Product Change Notification / GBNG-29PCCJ889

CCB 4980 Final Notice: Qualification of a tapeless lead frame for HV7224PG-G and HV7620PG-G catalog part numbers (CPN) available in 64L PQFP (20x14x3.4mm) package at CARS assembly site.

CCB 4980
Pre and Post Change Summary
PCN #: GBNG-29PCCJ889

LEAD FRAME COMPARISON

Pre Change

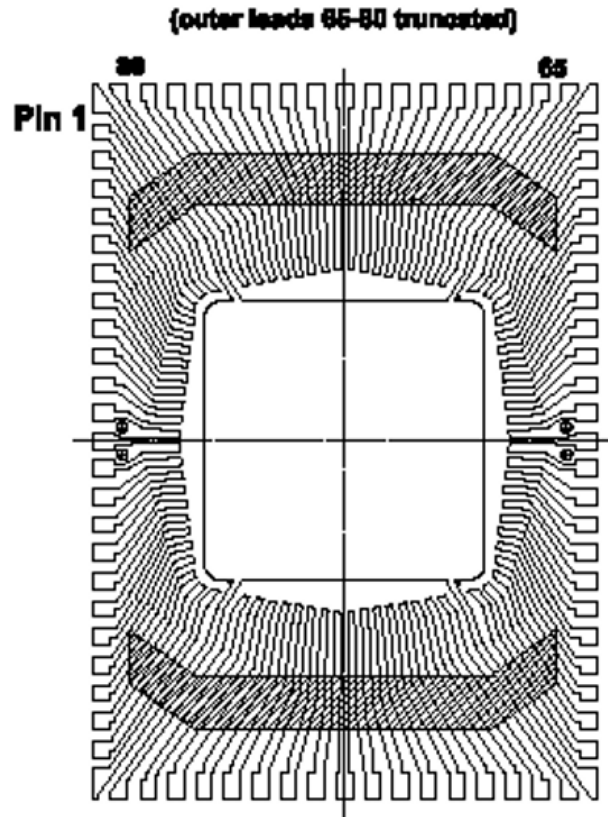
Kapton taped lead frame

Post Change

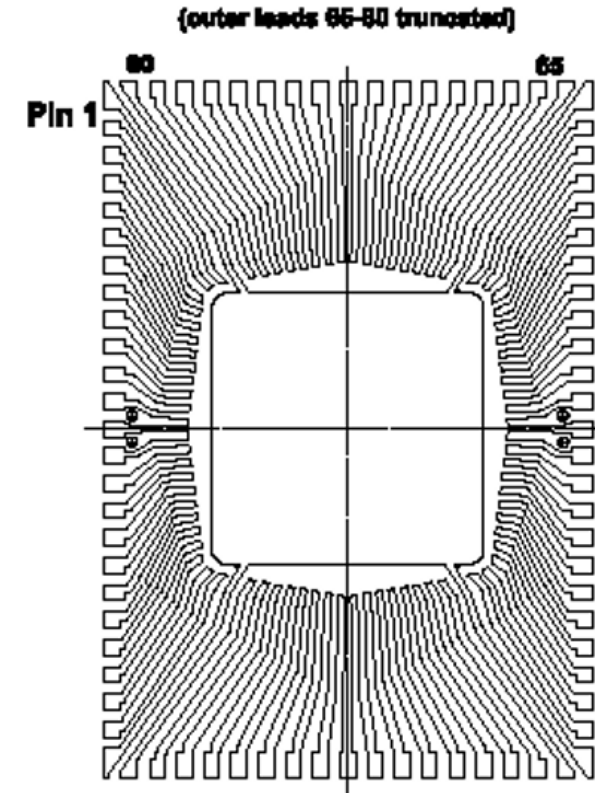
No tape lead frame
